Adaptable Housing & Accessibility Report

Development Application

16 Macpherson Street,
Warriewood,
NSW 2102

Project: 16 Macpherson Street, Warriewood
Document Type: Adaptable Housing and Accessibility Report
Our Reference: P223_023-2 (ACCESS AS4299) RT

Figure 1 - Dwelling Type B1 (pre/post adaptation)

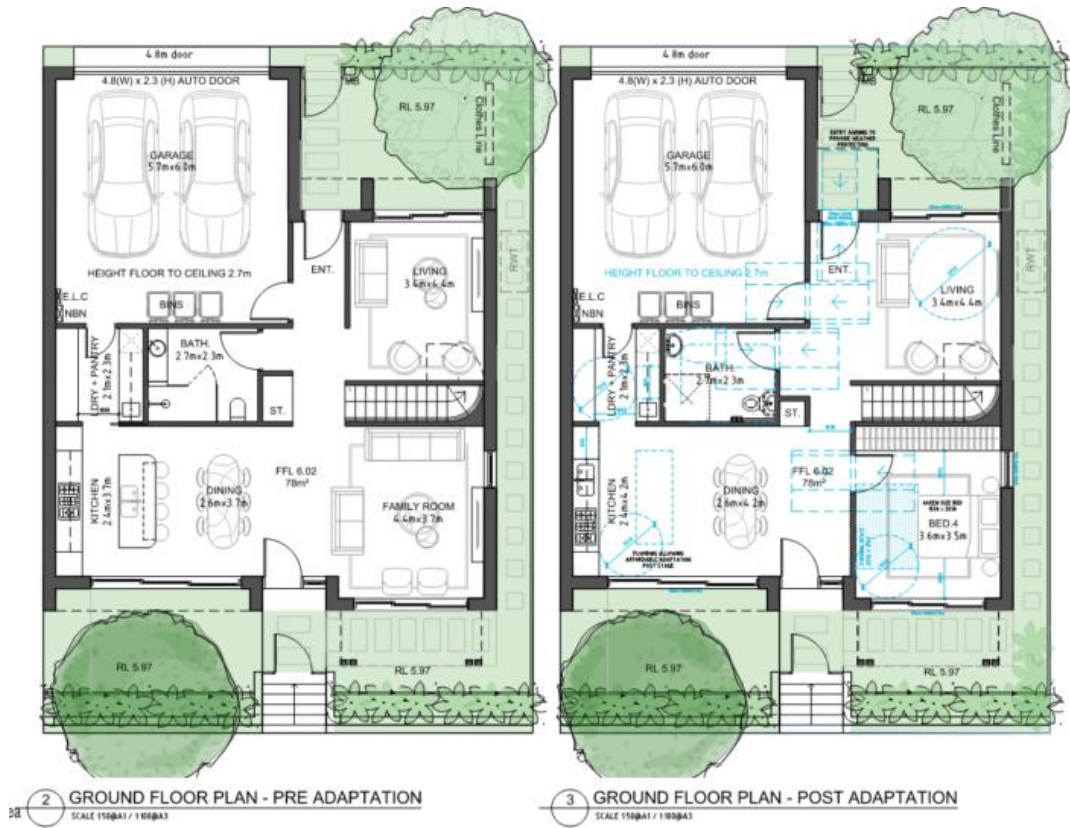
| DESCRIPTION | COMPLIANCE REQUIREMENT | COMMENT |
|-------------|--|--|
| General | Compliance is achieved with this clause – Drawings have been provided for the seven (7) nominated adaptable units, being all Type B1 layouts, demonstrating both pre-adaptation and post-adaptation layouts, in accordance with AS4299-1995. | The design is capable of achieving compliance subject to detailed documentation at the construction documentation phase. |

| DESCRIPTION | COMPLIANCE REQUIREMENT | COMMENT |
|--------------------|--|--|
| Window sills | Window sills at max 730mm above floor level to living and 600mm above floor levels to bedroom areas. | The window sills are noted as 130mm on the post adaptable plans and show compliance. |

| DESCRIPTION | COMPLIANCE REQUIREMENT | COMMENT |
|-------------------|--|--|
| Circulation Space | Provision shall be made for a circulation space to enable a 360° wheelchair turn, after furniture has been placed (2250mm diameter turning space will satisfy this requirement). | The design achieves compliance. |

| DESCRIPTION | COMPLIANCE REQUIREMENT | COMMENT |
|------------------|---|---|
| Bench Clearances | A minimum clearance of 1550mm between all opposing base cabinets and walls to be provided at the outset, to allow for a 180° turn, in accordance with AS1428.1. | The design achieves compliance. |

| DESCRIPTION | COMPLIANCE REQUIREMENT | COMMENT |
|--------------------|--|--|
| Circulation Spaces | The main bedroom shall be capable of accommodating a queen size bed (1530 x 2030mm), a wardrobe and 1000mm on either side of the bed and 1540mm turning space at the foot of the bed (generally at minimum 3600mm x 3600mm room clear of wardrobes). | The design achieves compliance. |

| DESCRIPTION | COMPLIANCE REQUIREMENT | COMMENT |
|---------------|---|---|
| Door | Main bathroom door to have 850mm clear opening width and circulation space in accordance with AS1428.1-2009. An exception can be made to the positioning of the washbasin, which can be located a minimum of 300mm clear of the swing of the door, in accordance with Figure 51 of AS1428.1-2009. | The design achieves compliance. |
